22559 EXTENSION ~ PWSA HIGHLAND PUMP BUNKERHILL ST, MELLON ST PITTSBURGH, 11TH WARD
OH CONSTRUCTION DRAWING 3

APPROVED
By Michael F. Higgins at 2:50 pm, Mar 21, 2025

22559 EXTENSION ~ PWSA HIGHLAND PUMP BUNKERHILL ST, MELLON ST PITTSBURGH, 11TH WARD				
OH CONSTRUCTION DRAWING 3				
ANSI D	SCALE N.T.S.	FRN NO. 20-0049	ORF. NO. 921767-T3	REV 1

PSWA HIGHLAND PARK PUMP ~ NEW BUSINESS 1500 N. NEGLY AVE CITY OF PITTSBURGH, 11TH WARD	OH CONSTRUCTION DRAWING 2
AND SCALE	N.T.S.
PROJECT NO.	20-0005
DRAWING NO.	761379-T2
REV.	2

No. 761379-T2

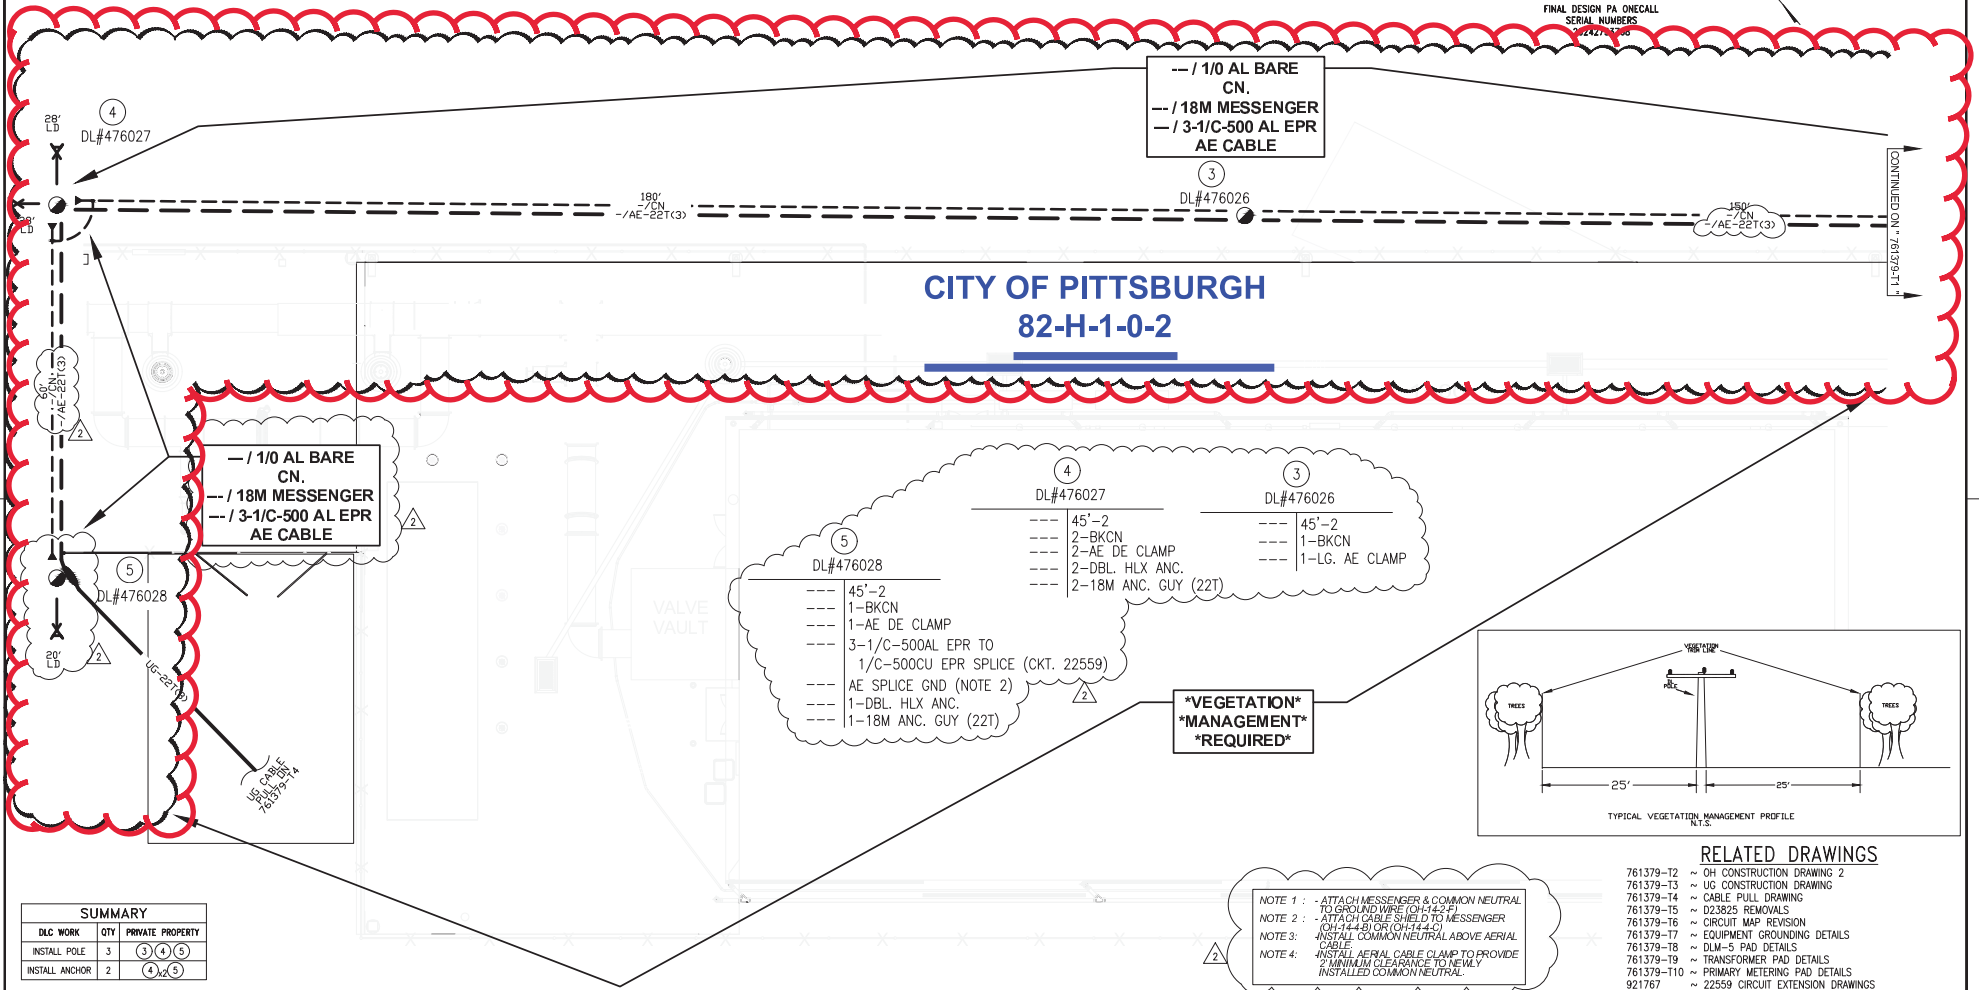
DLC CANNOT MOVE POLE TO EDGE OF R/W
DUE TO SEVERE IMPACT ON LINE ANGLE

DLC CANNOT MOVE POLE TO EDGE OF R/W
DUE TO SEVERE IMPACT ON LINE ANGLE
